Commit requests for COM 4.5

IEEE P802.3dj COM ad hoc

16 April 2024 (r0)

Summary of commit requests

Proposed changes to read_ParamConfigFile()

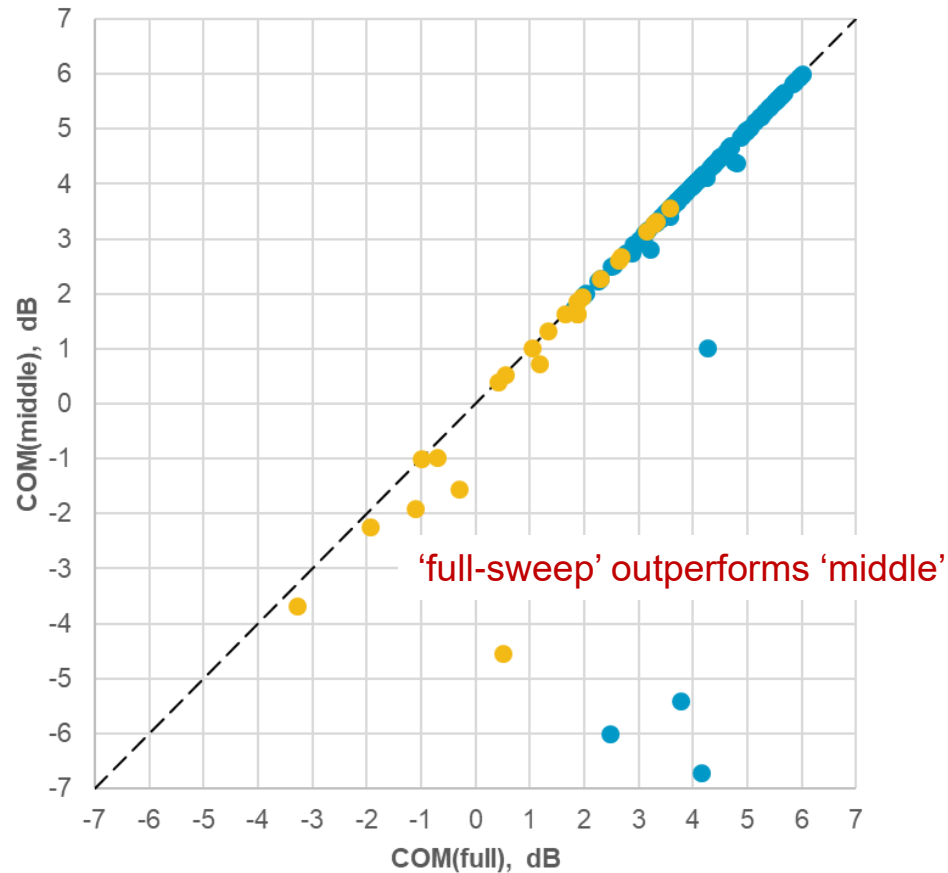
- In function `optimize_fom()`, the sampling time search is hard-coded to "middle_search".
- The "middle_search" algorithm is not guaranteed to find the sampling time that minimizes mean-squared error (or maximizes FOM) as prescribed in Annex 178A (especially when the RX-FFE coefficients are subject to constraints).
- The sampling time search method cannot be changed without editing the function.
- A "full sweep" option should be added to for the sampling time search and it should be made the default search algorithm.

Commit request 4p4_7 continued

529 OP.Do_Colored_Noise= xls_parameter(parameter, 'Do_Colored_Noise', false, 1);
530 OP.Do_White_Noise=xls_parameter(parameter, 'Do_White_Noise', false, 0);
531 OP.FFE_OPT_METHOD=xls_parameter(parameter, 'FFE_OPT_METHOD', false, 'MMSE'); % 'MMSE', 'FV-LMS', 'WIENER-HOPF',
532 OP.TS_SRCH_MODE = xls_parameter(parameter, 'TS_SRCH_MODE', false, 'full-sweep');
533

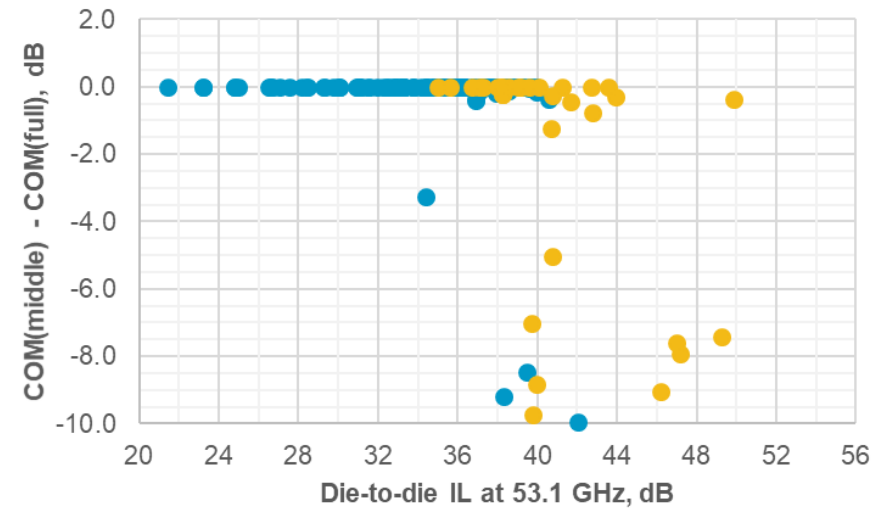
- Comparison of TS_SRCH_MODE = 'middle' to 'full-sweep'
- Test cases defined in [healey 3dj 01 2401](#)
- Based on COM 4.5beta1 with commit requests 4p4_5 through 4p4_8

Proposed changes to Create_Noise_PDF()

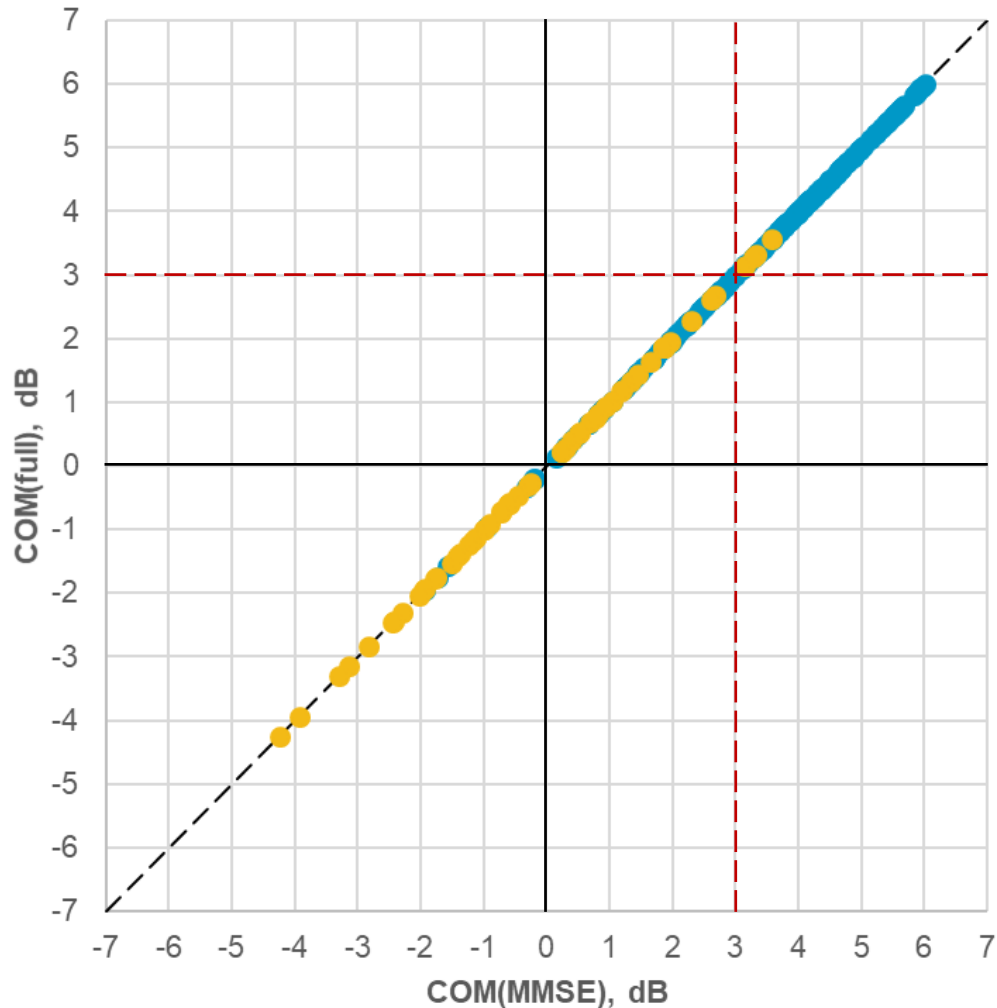
- In function Create_Noise_PDF(), sigma_N is assigned the value in structure “fom_result”.
- This value does not include filtering by the RX-FFE, even though all other results from Create_Noise_PDF() are at the output of the RX-FFE when OP.FFE_OPT_METHOD = 'MMSE'.

```
35 else
36   NS.sigma_TX =PSD_results.S_tn_rms;
37   NS.sigma_G = PSD_results.S_G_rms;
38   NS.sigma_rjit=PSD_results.S_rj_rms ;
39   NS.sigma_N = PSD_results.S_rn_rms;
40 end
41 % Equation 93A-41 %%
```
